Re: MP 10_0155 Redevelopment of the Former Allied Mills Site at 2-32 Smith Street, Summer Hill

Thank you for your letter of 27 June 2011 about the proposed mixed use development at the Former Allied Mills Site at 2-32 Smith Street, Summer Hill. Sydney Water has reviewed the proposal and provides the following comments for the Corporation's consideration.

Figure 1: Drinking Water Connection Points

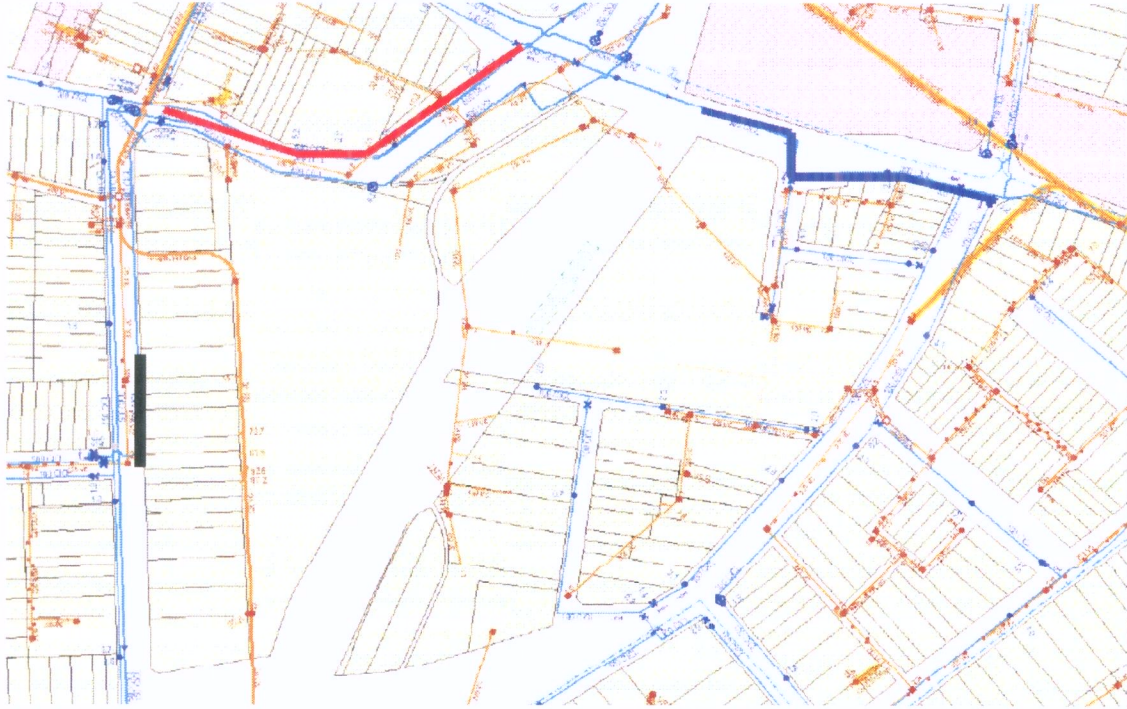
The existing water system has capacity to service the proposed development. The developer will need to design and construct a connection to the 300 mm water main on Longport Street to service development on the eastern side of the goods railway line (shown as the blue line in Figure 1).

To service the development on the western side of the goods railway line, the developer will need to design and construct a connection to either:

- the 300 mm trunk water main on Smith St (shown as the red line in Figure 1) or
- the 500 mm trunk water main on Edward St (shown as the black line in Figure 1).

Upsizing of local water mains may be required in accordance with the Water Supply Code of Australia. Amplifications to the network will be determined by engineering analysis methods consistent with the Water Supply Code of Australia (Sydney Water Edition WSA 03-2002), and will be determined at a later stage when the developer applies for a Section 73 Certificate.

The connections will need to be sized and configured according to the Water Supply Code of Australia (Sydney Water Edition WSA 03-2002). Evidence of Code compliance should be attached with the extension design.

Figure 2: Wastewater Connection Points

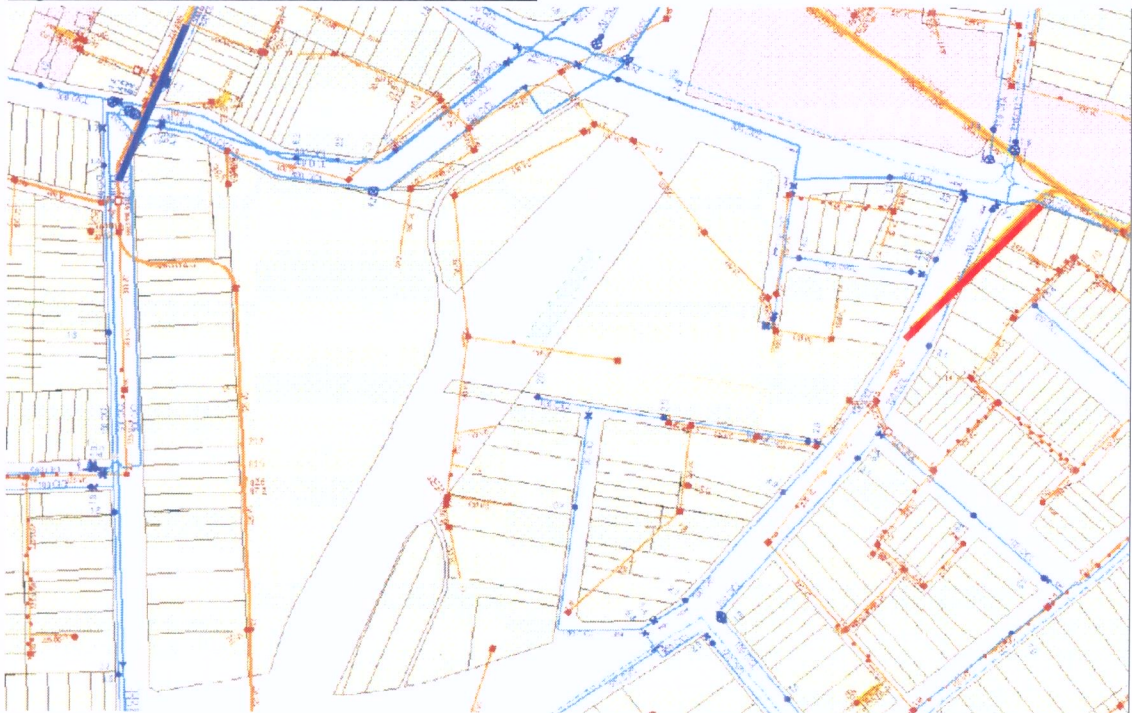
The existing wastewater system has capacity to service the proposed development. The developer will need to design and construct a connection to the water submain located at Old Canterbury Road to service development on the eastern side of the goods railway line (shown as the red line in Figure 2).

To service the development on the western side of the goods railway line, the developer will need to design and construct a connection to the water submain at the intersection of Edward Street and Smith Street (shown as the blue line in Figure 2).

The connections will need to be sized and configured according to the Sewerage Supply Code of Australia (Sydney Water Edition WSA 03-2002). Evidence of Code compliance should be attached with the extension design.
